**EOG RESOURCES, INC.**

**MOXA ARCH DEIS COMMENTS**

Re: EOG Resources, Inc.'s Comments Regarding the Moxa Arch Area Infill  
Gas Development Project Draft Environmental Impact Statement

**FIGURE 1: Surface Disturbance  
 Proposed Action vs Directional Drilling  
 186 wells per year - vertical**

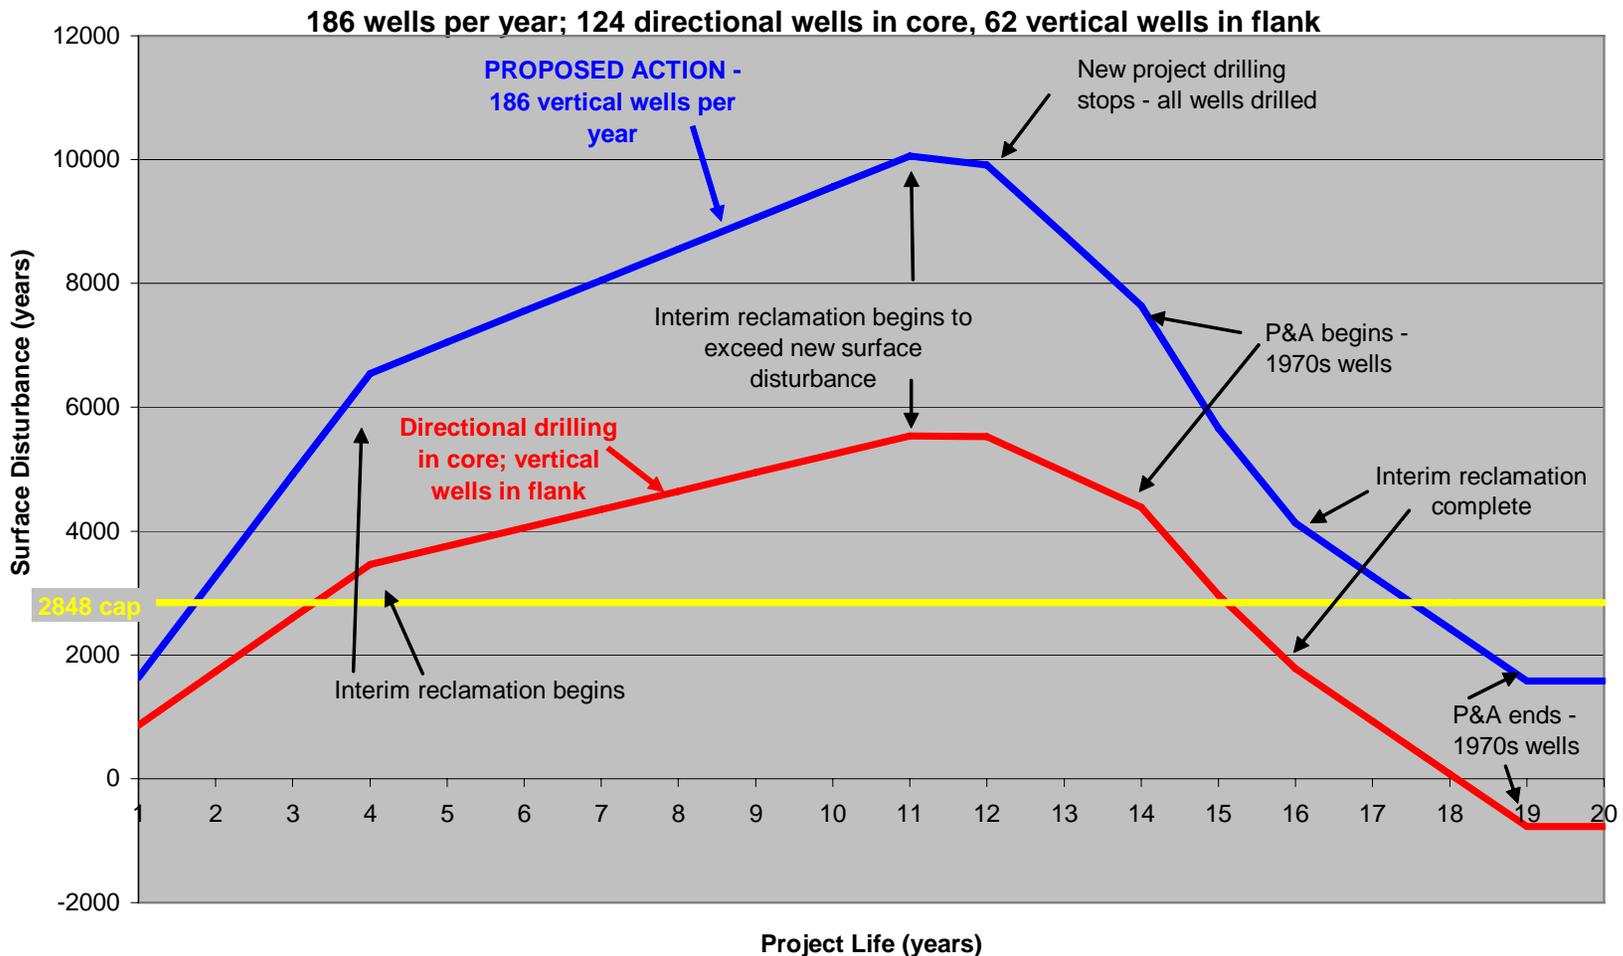
The graph in Figure 1 illustrates that no new wells will be drilled in the MAA in approximately two years after the approval of the ROD if wells are drilled vertically throughout the MAA, as proposed by the Operators, if Alternative B is adopted. Total new surface disturbance would peak at approximately 10,000 acres. Successful reclamation would allow the Operators to decrease new surface disturbance below a 2,848-acre limit by about year 18.

The graph in Figure 1 also illustrates how surface disturbance from directional wells could be expected to increase over time. It incorporates the following assumptions, in addition to the assumptions described for Figure 1:

The graph in Figure 1 illustrates that no new wells will be drilled in the MAA between years 4 and 5 after the approval of the ROD if they are drilled directionally in the core and vertically throughout the flank. Total new surface disturbance would peak at approximately 5,500 acres. Successful reclamation would allow the Operators to decrease new surface disturbance below a 2,848-acre limit by about year 15.

**FIGURE 2: Project Life and Drilling Activity - Directional vs Vertical Wells  
Alternative B  
2848-acre cap, 1861 wells**

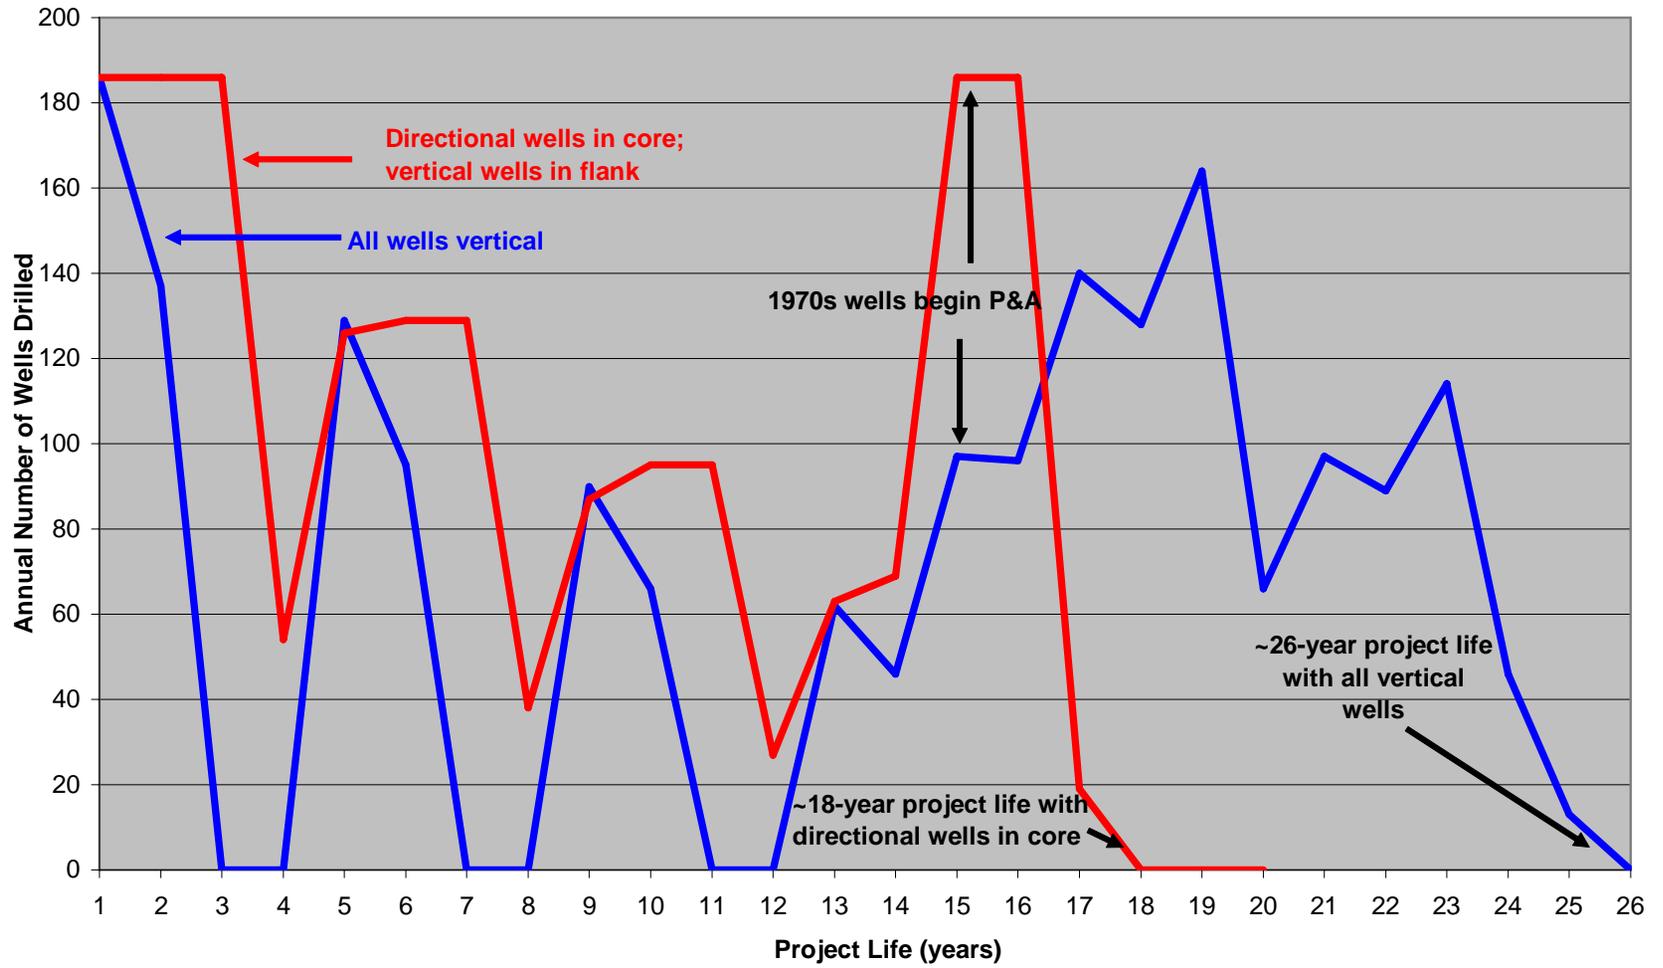
Figure 2 illustrates an initial brief period of well drilling activity whether all the wells are drilled vertically or whether only the core wells are drilled directionally. The number of wells that could be drilled annually would vary substantially based upon the success of reclamation. Year 5 shows more wells being drilled because interim reclamation on the initial wells would presumably be successful by year 5, allowing more drilling than allowable in the previous year. Drilling activity within any particular year would depend entirely on reclamation success, which means that no company would be able to plan for future operations with assurance that drilling would, in fact, be permitted. This graph does not account for the time required by the BLM to confirm reclamation success, which may require an additional growing season, further decreasing the number of wells that would be permitted after the cap is reached.

Surface disturbance would approximate the cap level until the wells drilled in the 1970s begin to be plugged and abandoned, shown in Figure 2 to be about 14 years after project approval. In addition, the steep decline exhibited by the vertical well curve in year 20 does not reflect additional 1970-era wells that may be P&A during this time period forward. If the 1970-era wells are plugged and abandoned at a greater rate than shown in this graph, annual project wells drilled would (theoretically) continue to generally increase beyond year 20 until all project wells are drilled in year 22. The older wells, however, may be re-evaluated as warranted by evolving technologies and reconsideration of geologic prospects. The possibility that the older wells could be recompleted or drilled to deeper targets cannot be discounted; thus, reclamation of the older well pads is not a certainty. Nonetheless, the assumptions made to support this analysis
